SERVICE LETTER

No. 543

Piper Aircraft Corporation

Subject: Induction System Drain Tube Relocation

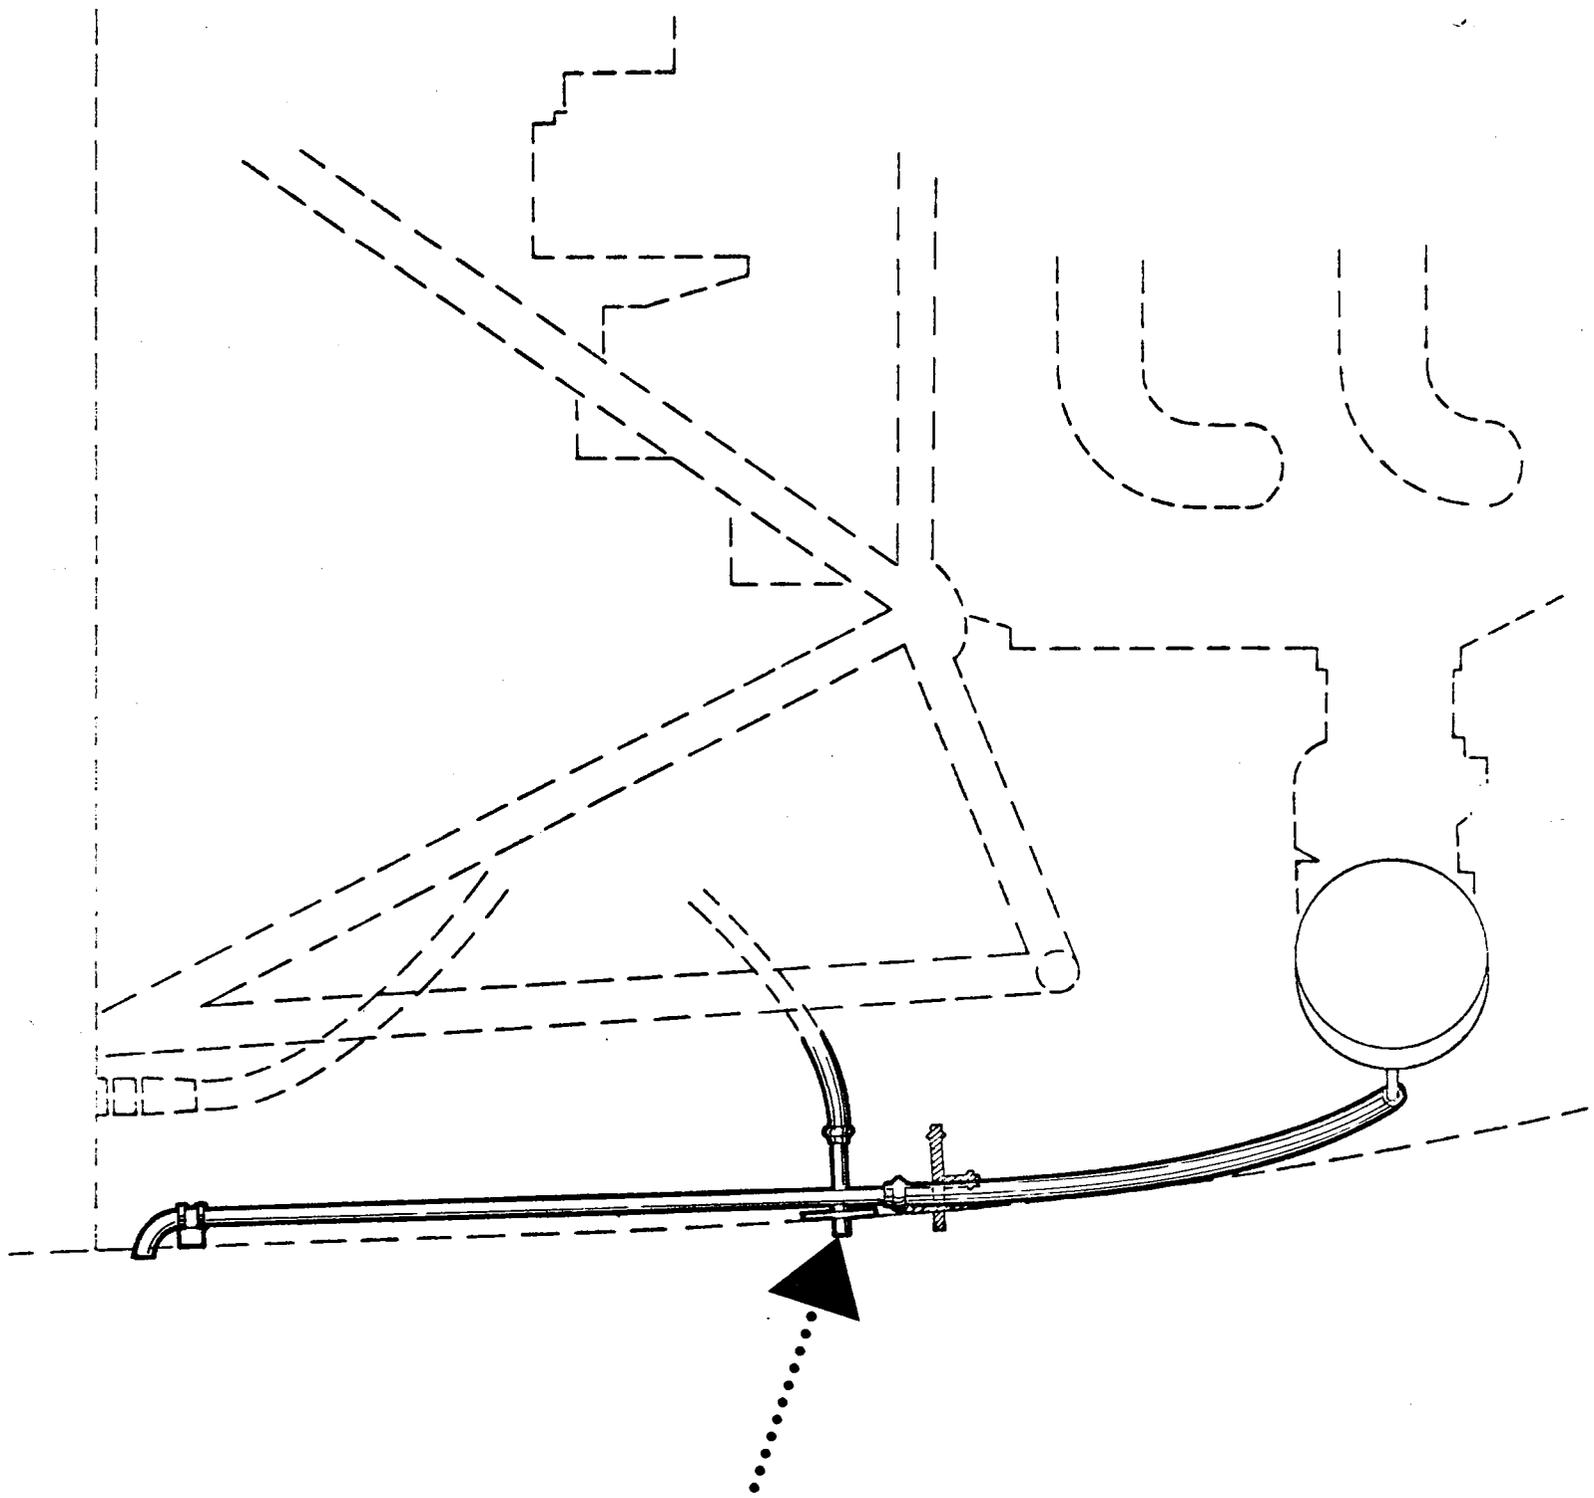
Purpose: To provide material and instructions for the relocation of the induction system drain tube in the engine cowling. This modification will provide increased clearance between the drain tube and the exhaust system (see sketch on reverse side of this letter for general information).

Instructions: Contained in Kit No. 760 351, Induction System Drain Tube Relocation.
